SUBJECT: ISSUANCE OF AMENDMENT NOS. 188, 188 AND 185 TO FACILITY OPERATING  
LICENSES DPR-38, DPR-47 AND DPR-55 - OCONEE NUCLEAR STATION,  
UNITS 1, 2 AND 3 (TACS 75344, 75345, 75346)

The amendments revise the Pressure/Temperature Limits and the Low Temperature  
Overpressure Protection system operability requirements in Section 3.1 of the  
TSS and revise the associated bases.

Replace the following pages of the Appendix "A" Technical Specifications with the enclosed pages. The revised pages are identified by Amendment number and contain vertical lines indicating the areas of change.

SAFETY-EVALUATION-BY-THE-OFFICE-OF-NUCLEAR-REACTOR-REGULATION  
RELATED-TO-AMENDMENT-NO.-188-TO-FACILITY-OPERATING-LICENSE-DPR-38  
AMENDMENT-NO.-188-TO-FACILITY-OPERATING LICENSE-DPR-47  
AMENDMENT-NO.-185-TO-FACILITY-OPERATING-LICENSE-DPR-55

Figure 3.1.2-1A

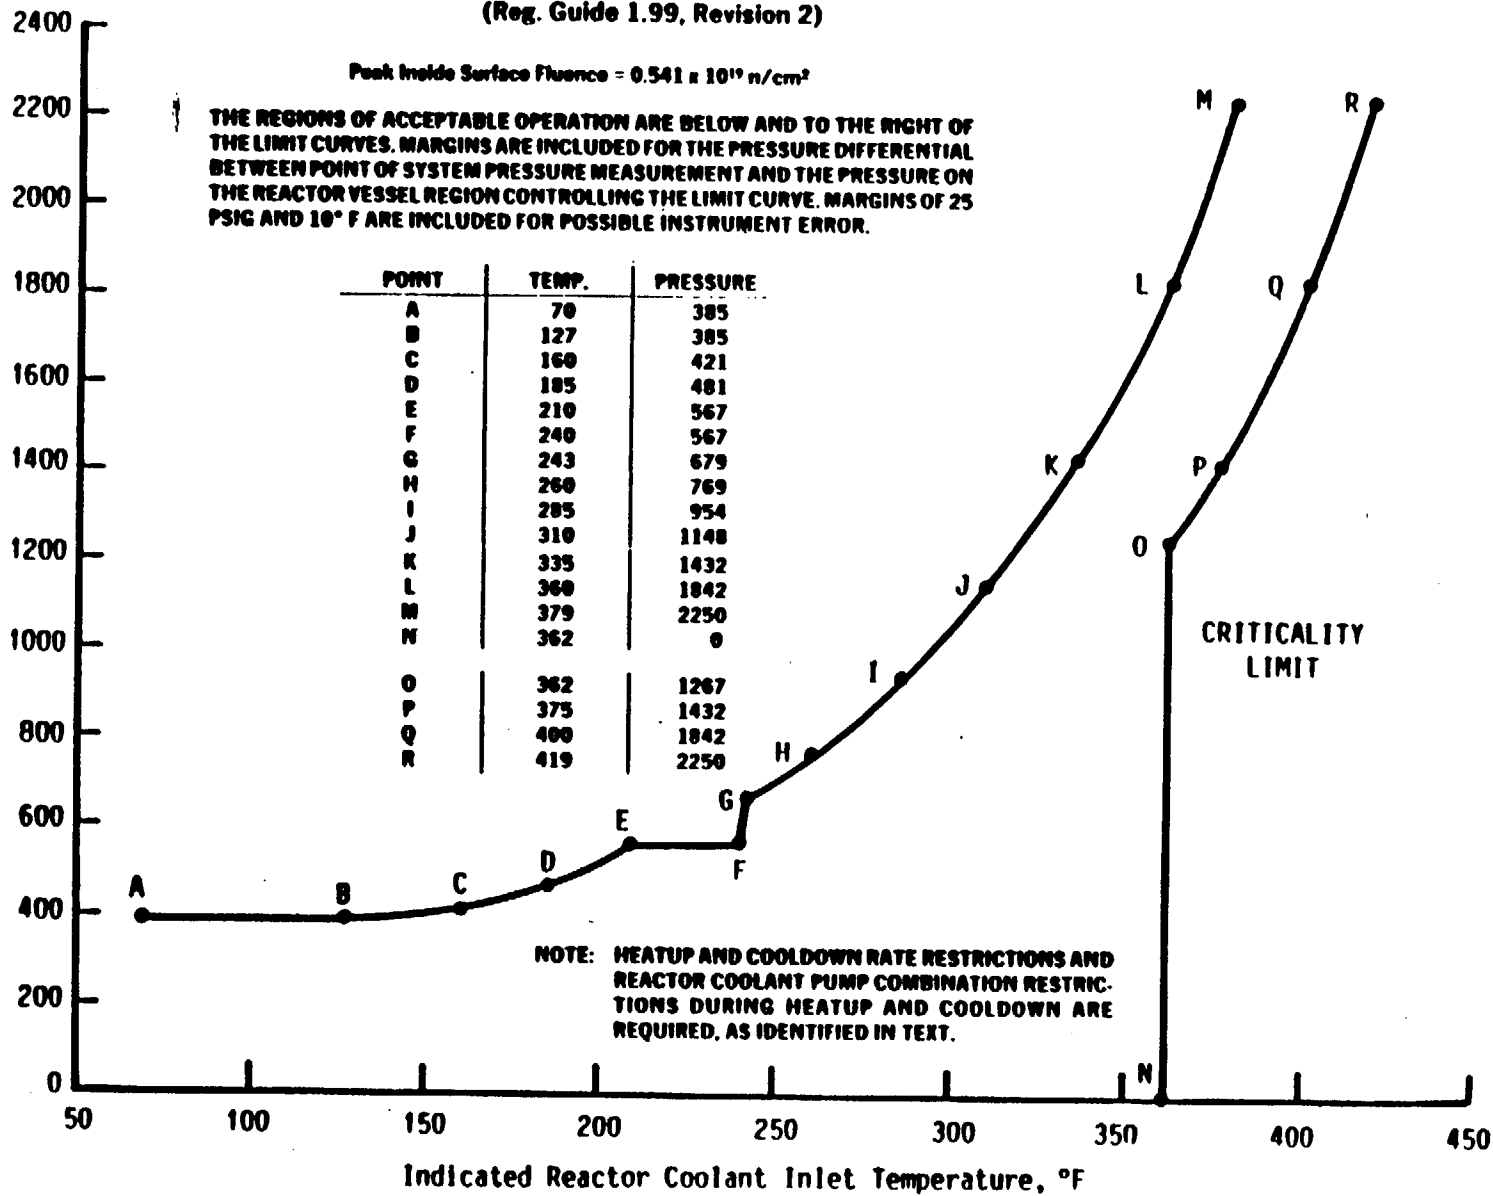
The changes to P/T limits are in response to Generic Letter (GL) 88-11, "NRC Position on Radiation Embrittlement of Reactor Vessel Materials and Its Effect On Plant Operation." The current P/T limit curves are based on an assumed design basis neutron fluence through 15 effective full power years (EFPYs). The proposed P/T limit curves were developed based on the guidance of Regulatory Guide (RG) 1.99, Rev. 2, "NRC Position on Radiation Embrittlement of Reactor Vessel Materials and Its Impact on Plant Operations," and they are applicable for a period of up to 15 EFPYs. Prompted by the P/T Limit revisions, changes to the low temperature overpressure protection (LTOP) system requirements (TS 3.1.9.2) have been proposed to assure proper protection to the reactor vessel.

For the limiting beltline material, weld SA-1585, the staff calculated the ART to be  $184.1^{\circ}F$  at  $1/4T$  ( $T$  = reactor vessel beltline thickness) and  $140^{\circ}F$  for  $3/4T$  at 15 EFPY.<sup>2</sup> The staff used a neutron fluence of  $3.26E18$  n/cm<sup>2</sup> at  $1/4T$  and  $1.18E18$  n/cm<sup>2</sup> at  $3/4T$ . The ART was determined by Section 1 of RG 1.99, Rev. 2, because the limiting weld material was not included in the surveillance capsules.

The licensee calculated the ARTs of  $184^{\circ}F$  and  $140^{\circ}F$  at  $1/4T$  and  $3/4T$ , respectively. Substituting the ARTs of  $184^{\circ}F$  and  $140^{\circ}F$  into equations in SRP 5.3.2, the staff verified that the proposed P/T limits for heatup, cooldown, and hydrotest meet the beltline material requirements in Appendix G of 10 CFR Part 50.

Figure 3.1.2-1B

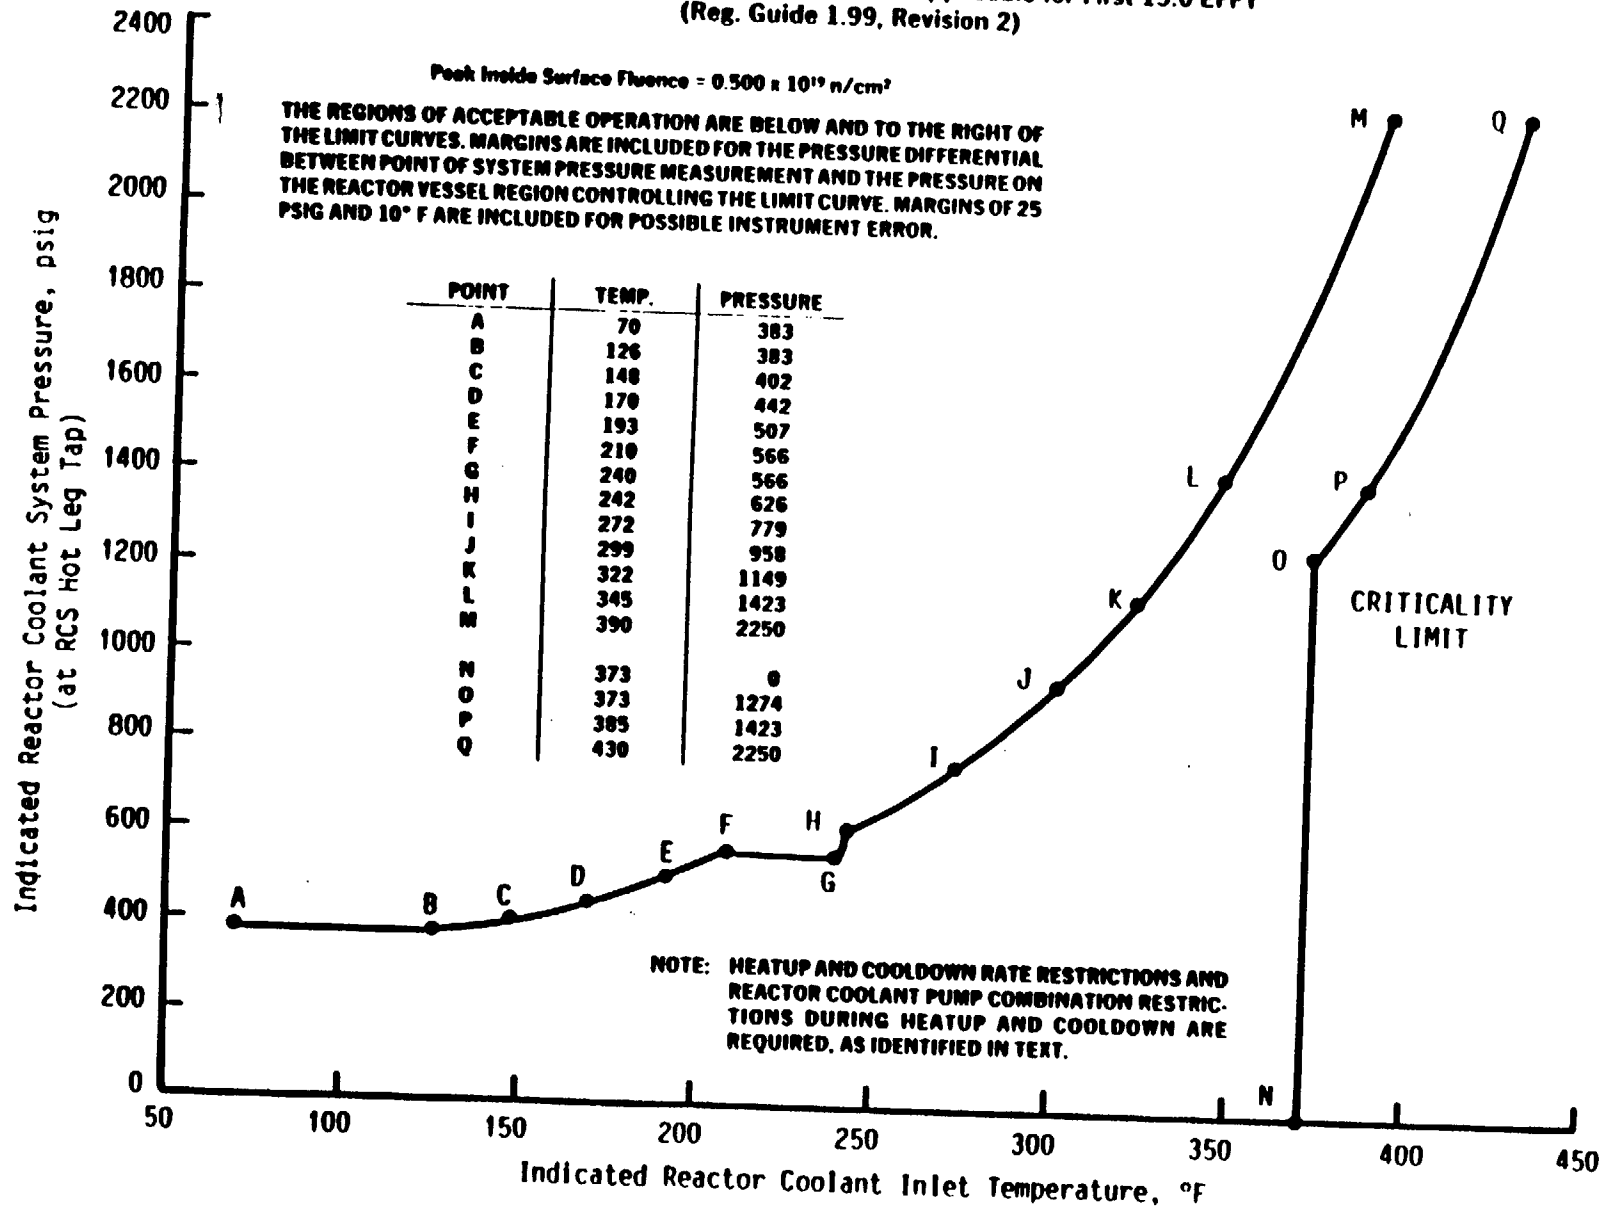
For the limiting beltline material, weld WF-154, the staff calculated the ART to be  $191^{\circ}F$  at  $1/4T$  and  $138.3^{\circ}F$  at  $3/4T$ . The staff used a neutron fluence of  $3.01E18$  n/cm<sup>2</sup> at  $1/4T$  and  $1.09E18$  n/cm<sup>2</sup> at  $3/4T$ . The ART was determined by Section 1 of RG 1.99, Rev. 2, because the limiting material was not included in the surveillance capsules.

The licensee selected the weld, WF-25, as the limiting material and calculated the ARTs of 193°F and 139°F at 1/4T and 3/4T, respectively. The licensee's ARTs are conservative; therefore, they are acceptable. Substituting the ARTs of 193°F and 139°F into equations in SRP 5.3.2, the staff verified that the proposed P/T limits for heatup, cooldown, and hydrotest meet the beltline material requirements in Appendix G of 10 CFR Part 50.

Figure 3.1.2-1C

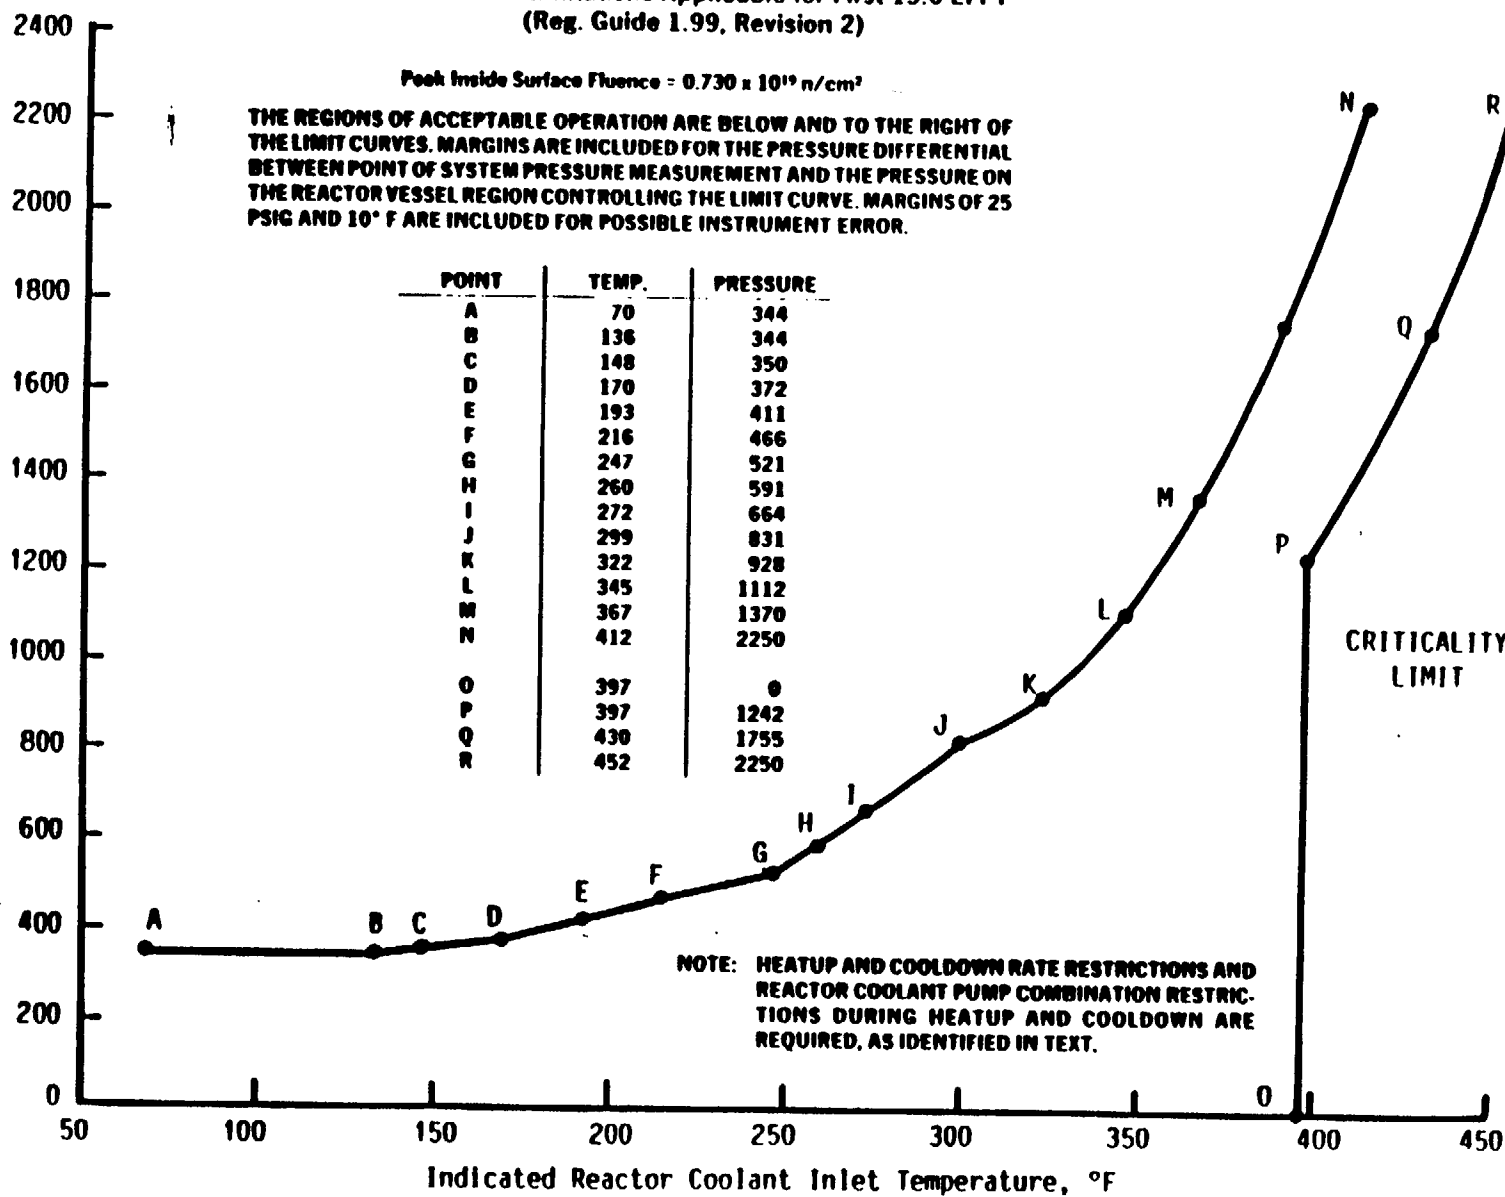
For the limiting beltline materials, welds WF-200 and WF-70, the staff calculated the ART to be 202.2°F at 1/4T and 170.1°F for 3/4T at 15 EFPY. The staff used a neutron fluence of 3.18E18 n/cm<sup>2</sup> at 1/4T and 1.15E18 n/cm<sup>2</sup> at 3/4T. The ART was determined by Section 1 of RG 1.99, Rev. 2, because the limiting material was not included in the surveillance capsules.

The licensee selected welds WF-67 and WF-70 as the limiting materials at the 1/4T and 3/4T locations, respectively, and calculated the ARTs of 195°F at 1/4T and 171°F at 3/4T. The difference between the staff's ART and the licensee's ART at the 1/4T location (202°F vs. 195°F) is because the licensee used a lower chemistry factor in the ART calculation. Substituting the ARTs of 202.2°F and 171°F into equations in SRP 5.3.2, the staff verified that the proposed P/T limits for heatup, cooldown, and hydrotest meet the beltline material requirements in Appendix G of 10 CFR Part 50. The licensee's P/T limits have sufficient safety margin such that with a lower ART the limits satisfy the Appendix G calculation.
